■AUDIO SYSTEM

1. Description

▶ Head Unit Specifications ◀

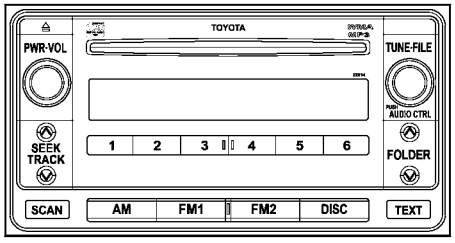
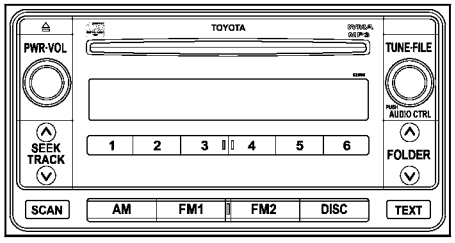
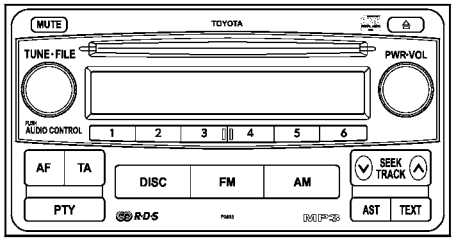
- The audio specifications for the destinations shown in the table below have been changed.

Destinations	Design	Specifications	Major changes
The equipment optional for all models except for Latin America	 04Z4MO02Y	● AM (9kHz)/ FM tuner ● CD player ● WMA and MP3 playback supported ● Manufacturer: Fujitsu TEN	● Cassette player abolished ● WMA and MP3 playback supported
The equipment optional for Latin America	 04Z4MO17	● AM (10kHz)/ FM tuner ● CD player ● WMA and MP3 playback supported ● Manufacturer: Panasonic	● Cassette player abolished ● WMA and MP3 playback supported
The equipment optional for South Africa GL grade models	 04Z4MO03Y	● AM (9kHz)/ FM tuner ● CD player ● RDS function provided ● MP3 playback supported ● Manufacturer: Pioneer	● MP3 playback supported

▶ Speaker Locations ◀

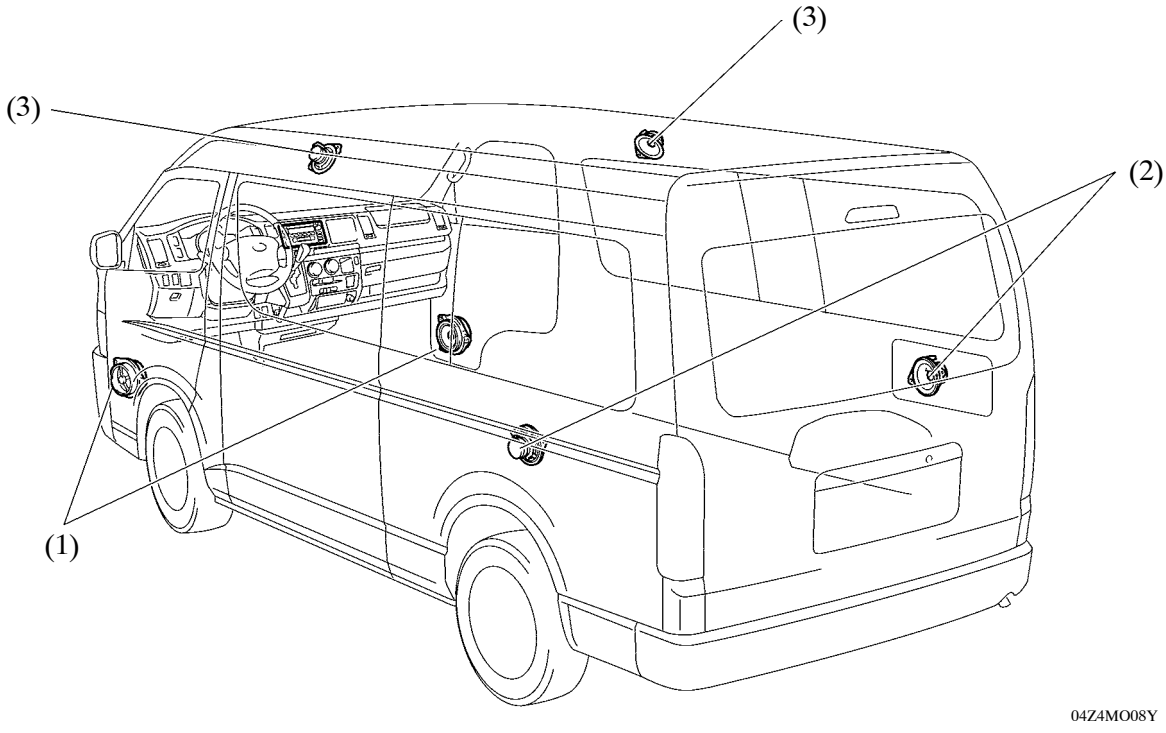
- The speakers used for the rear quarter speakers of both the 4 speaker system and 6 speaker system equipped models have been changed to the 10 cm diameter type, making them the same type as the roof speakers used for the 6 speaker system. With this change, the number of speaker bundles has been reduced from three to two, enhancing the serviceability.
